Engineering Review

EPC Planning & Community  
Development Department

**FINAL DRAINAGE REPORT  
FOR  
RETREAT AT TIMBERRIDGE  
FILING NO. 2**

PCD-ENGINEERING REVIEW COMMENTS  
IN BLUE BOXES WITH BLUE TEXT

## HEC-RAS CALCULATIONS

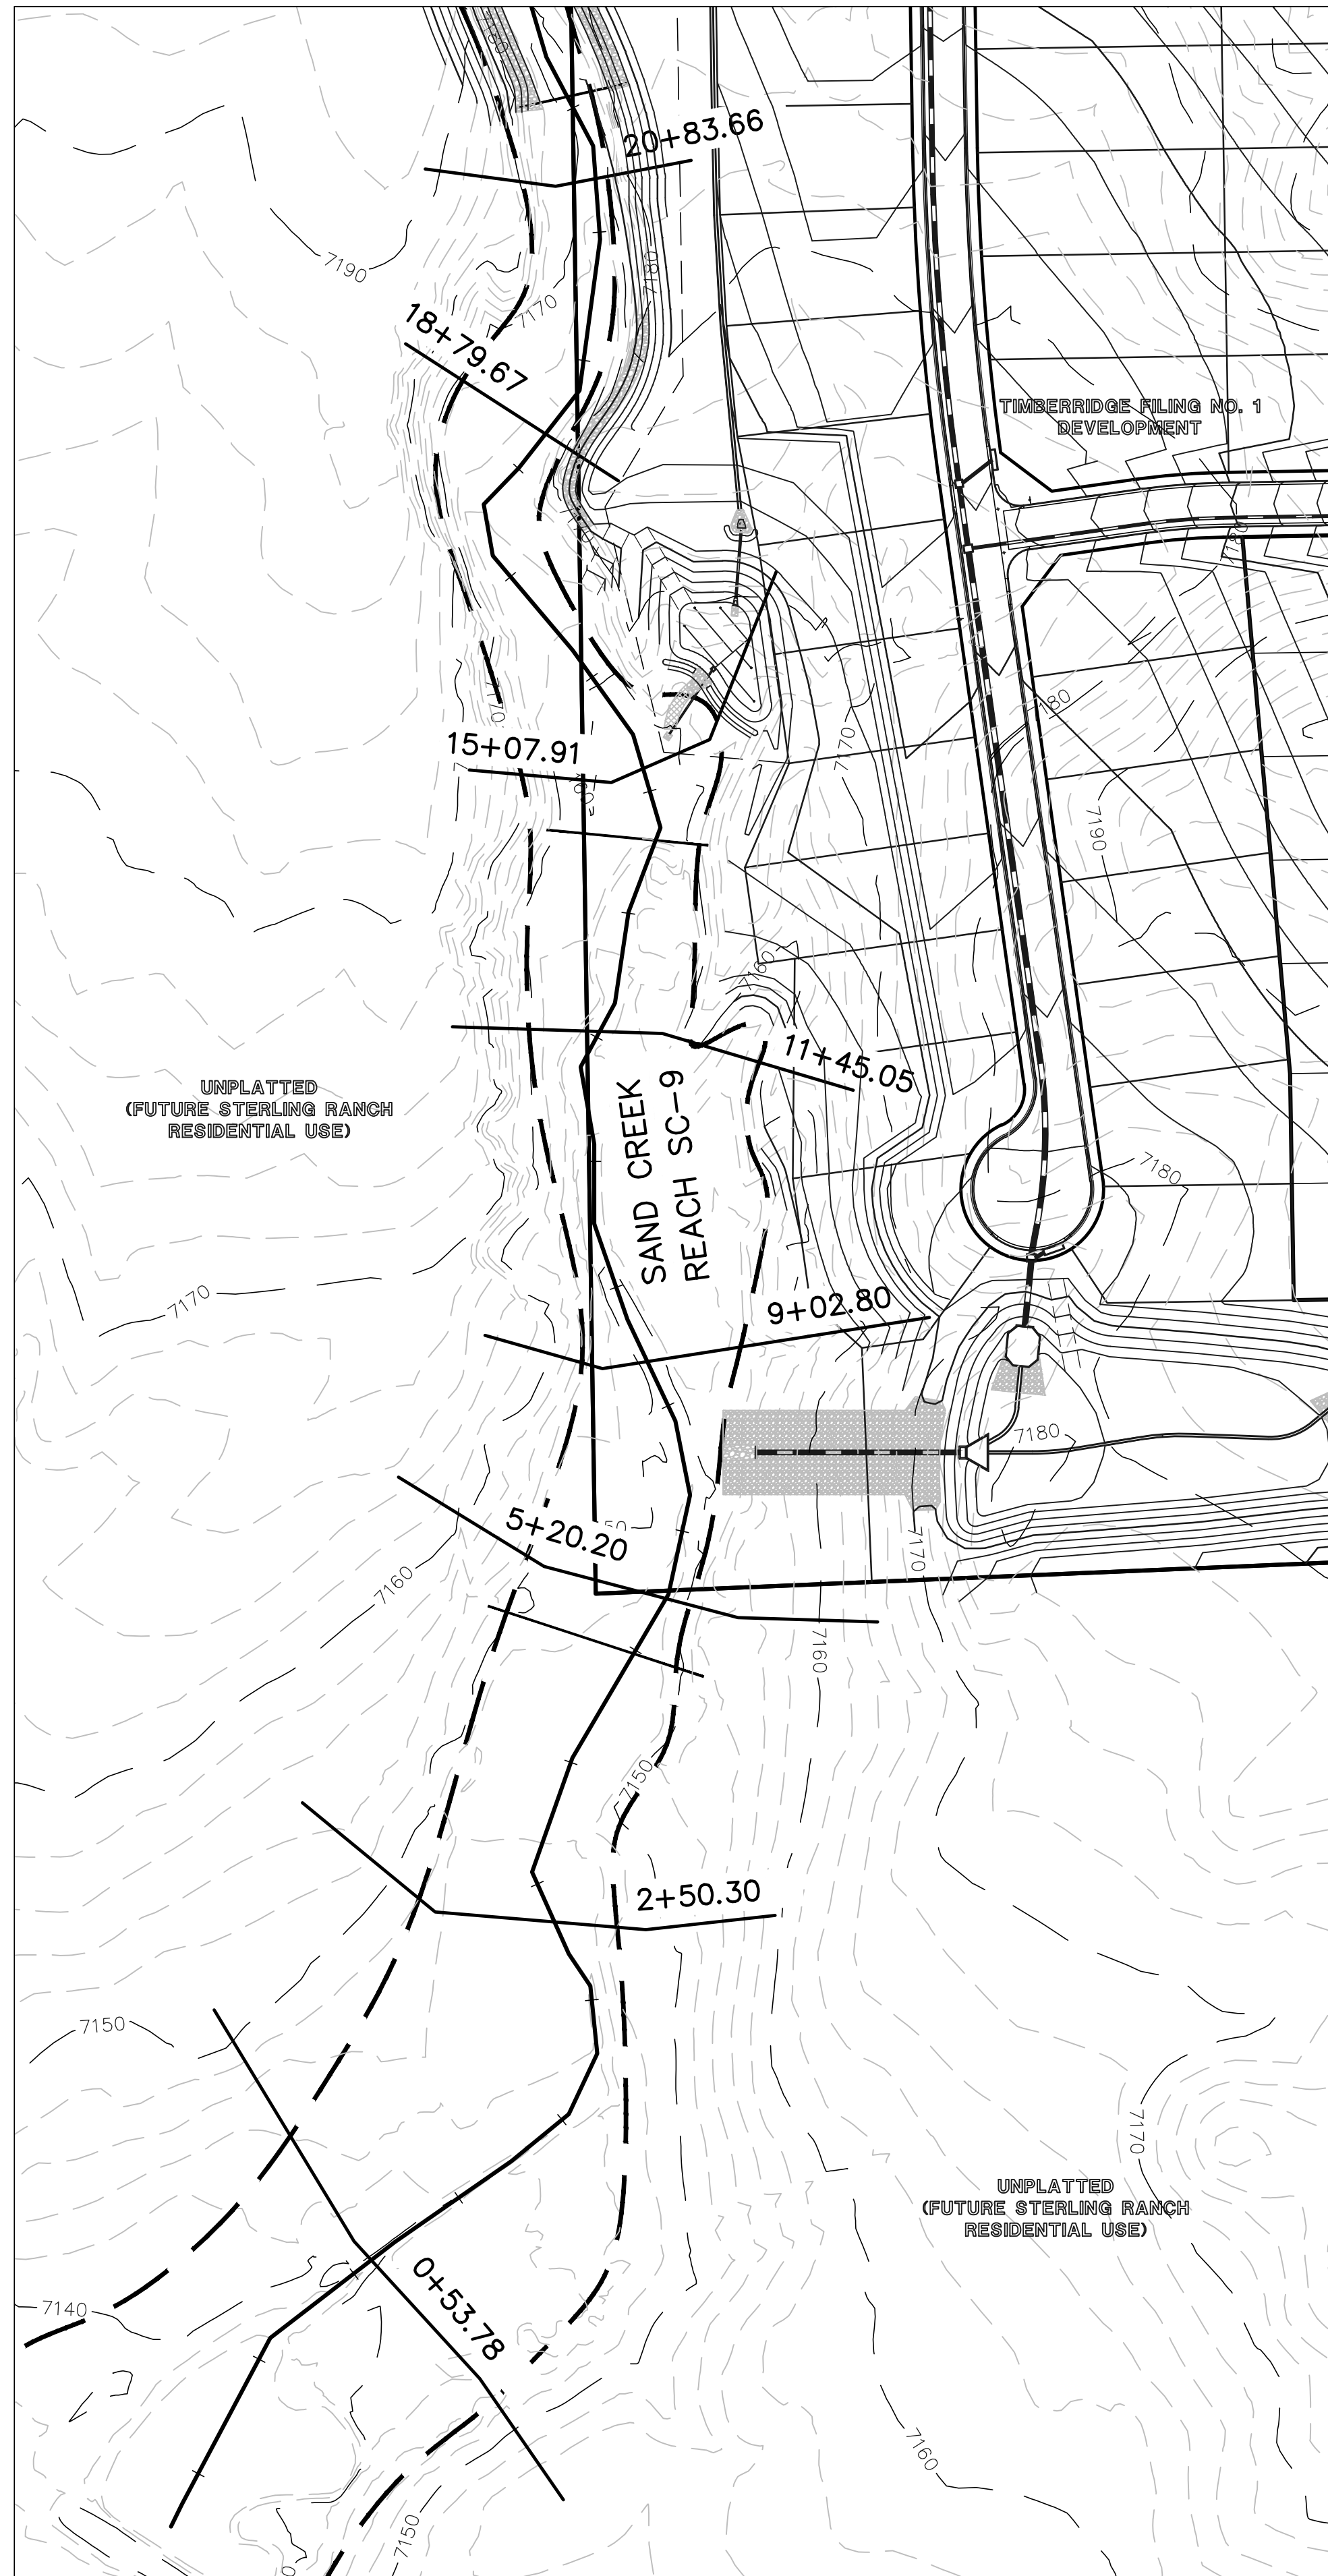
Please add the FEMA water surface elevation lines

EX Channel Sand Creek CL

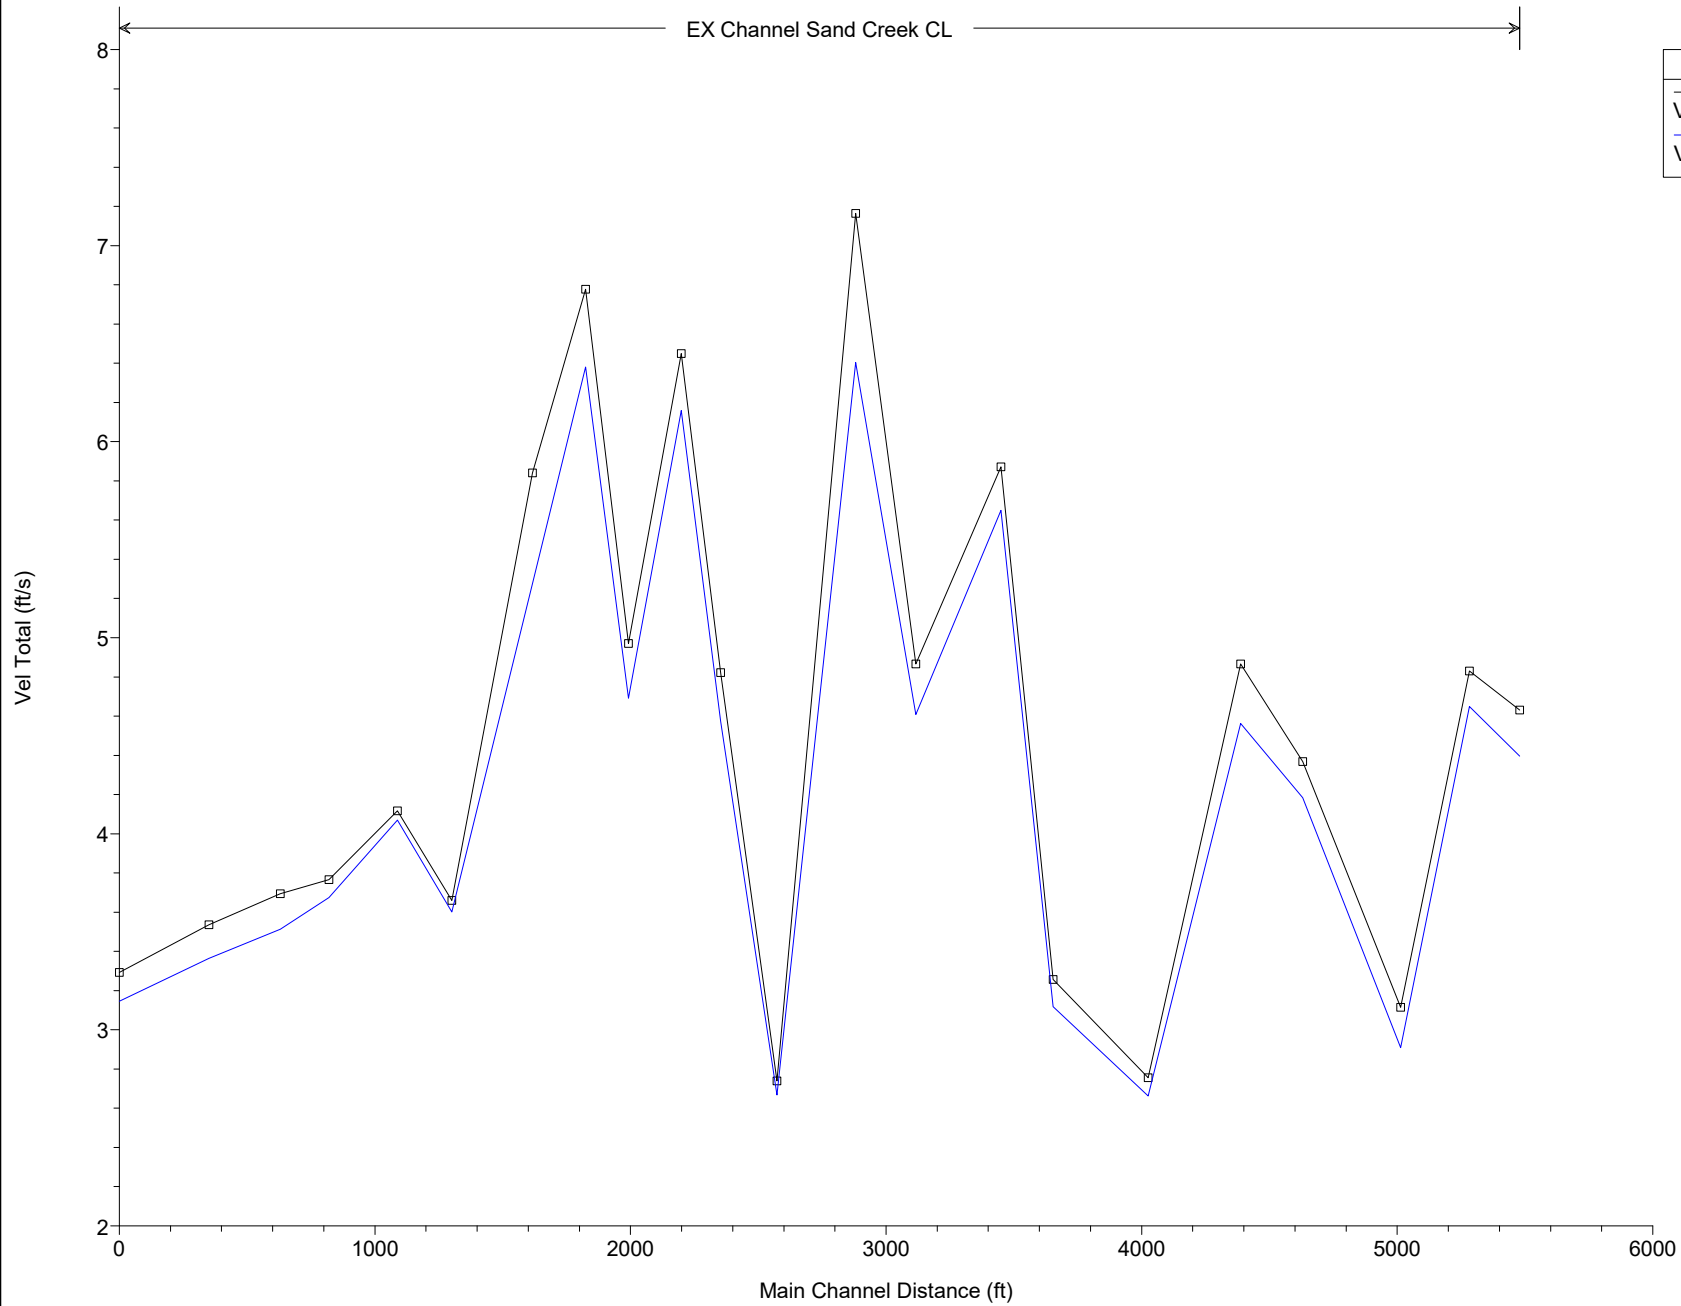
Please highlight the cross-sections within and adjacent to this plat.

Sand Creek Impro CL-PR

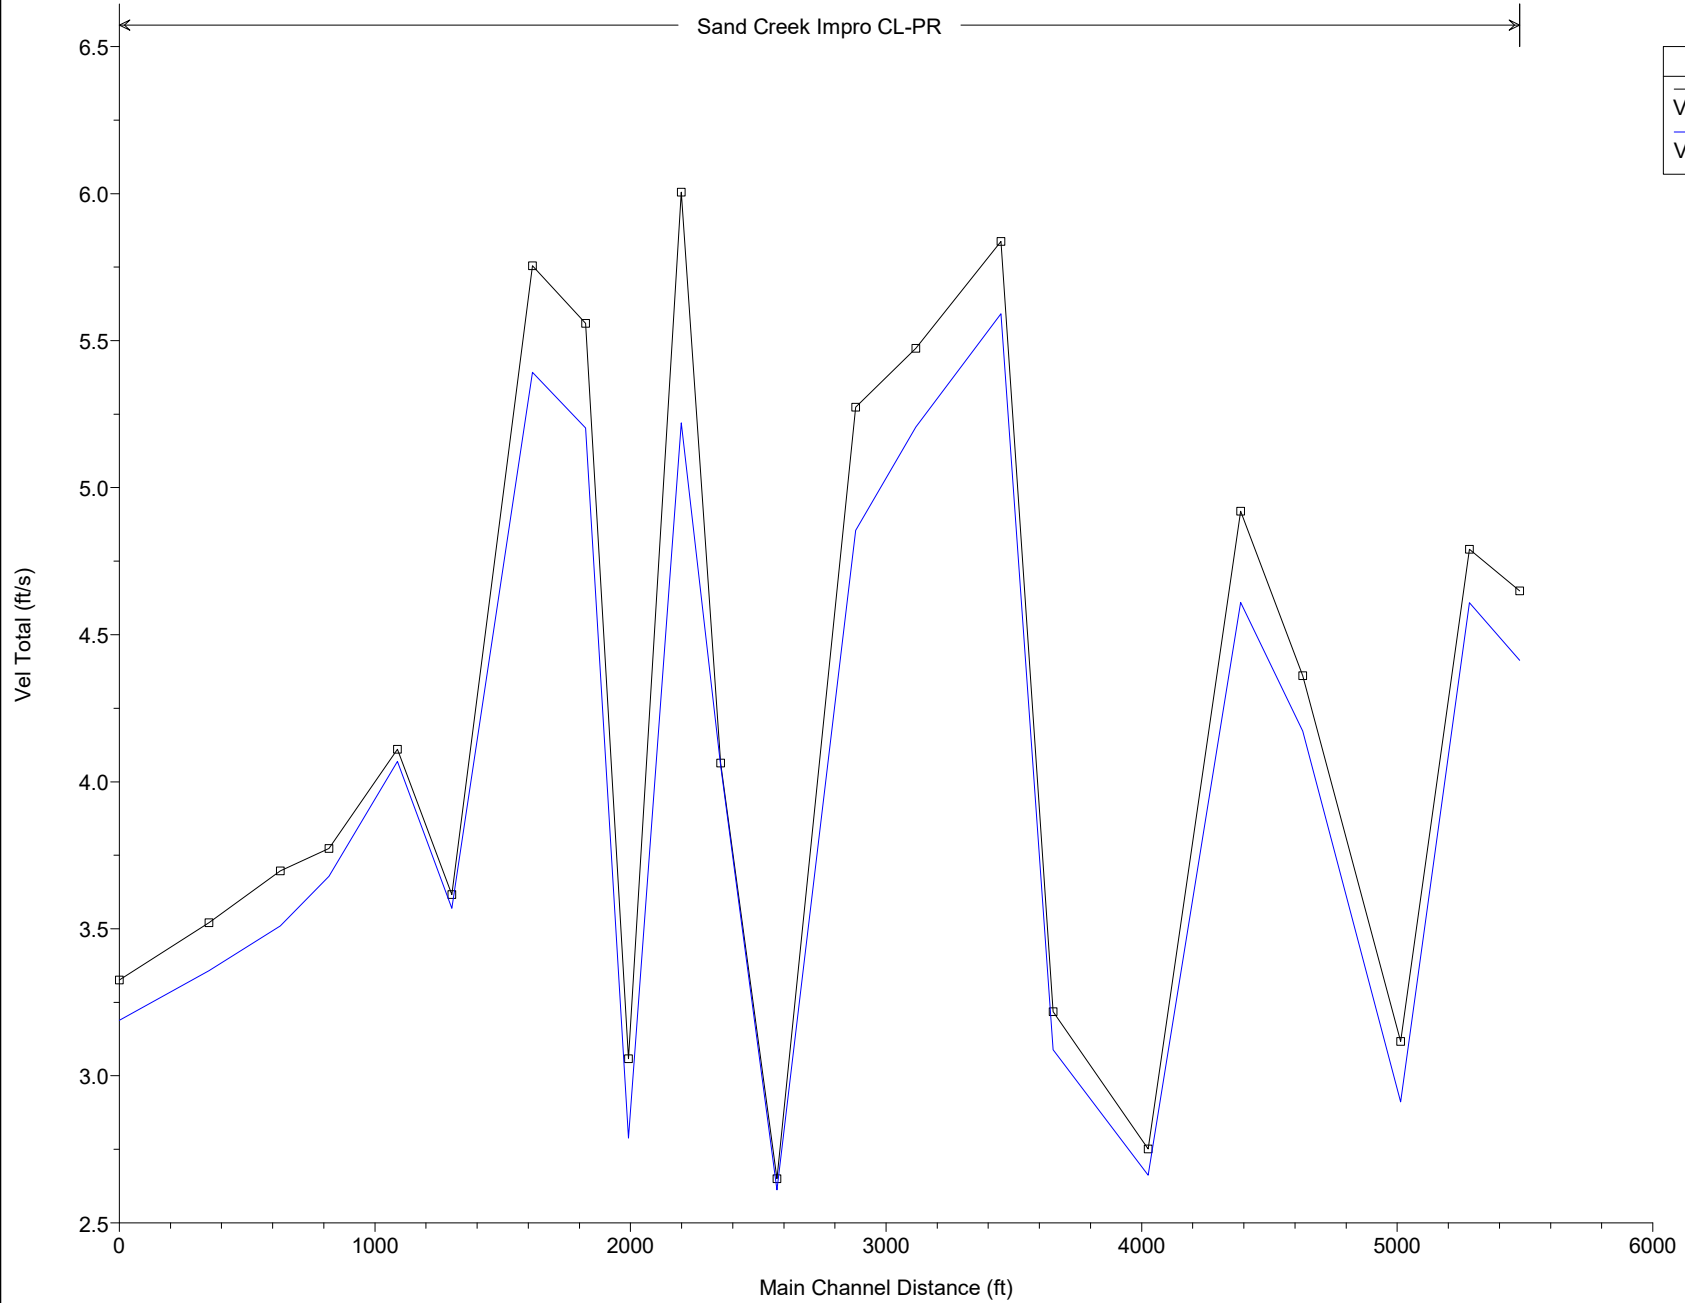
Please highlight the cross-sections within and adjacent to this plat.

**FINAL DRAINAGE REPORT - BASIN RUNOFF COEFFICIENT SUMMARY**

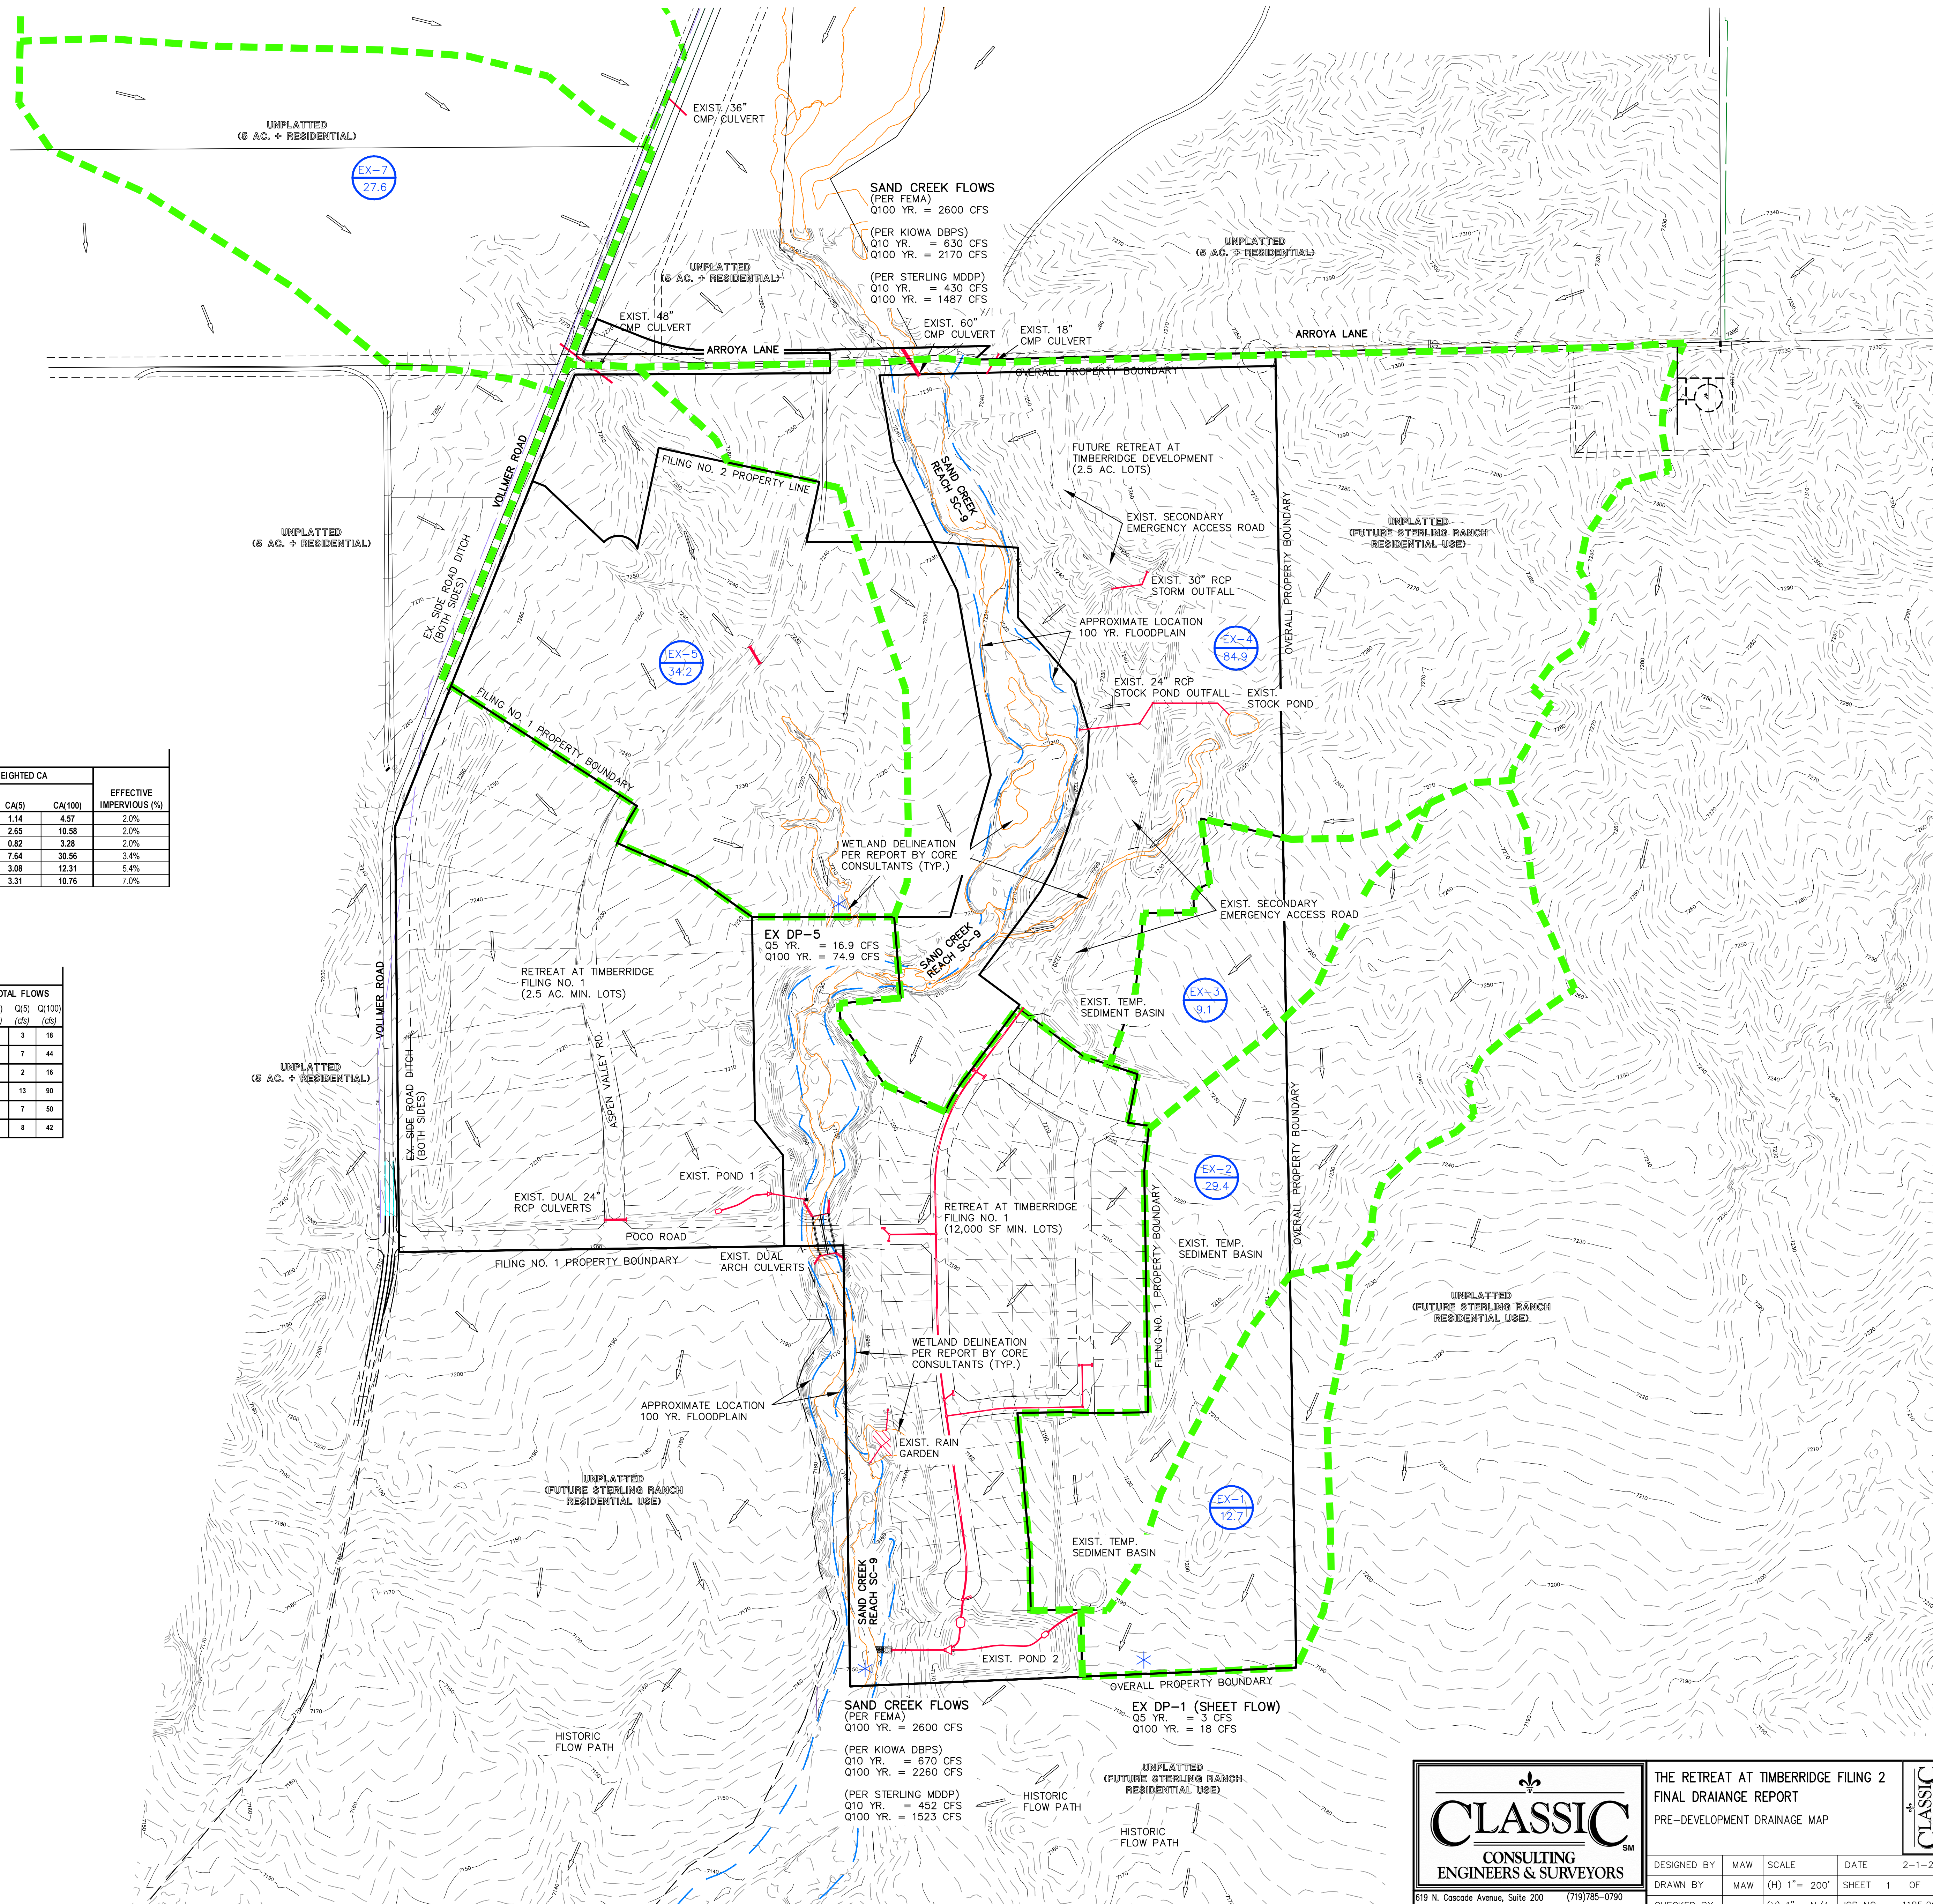
Move drainage plans to end of report pdf
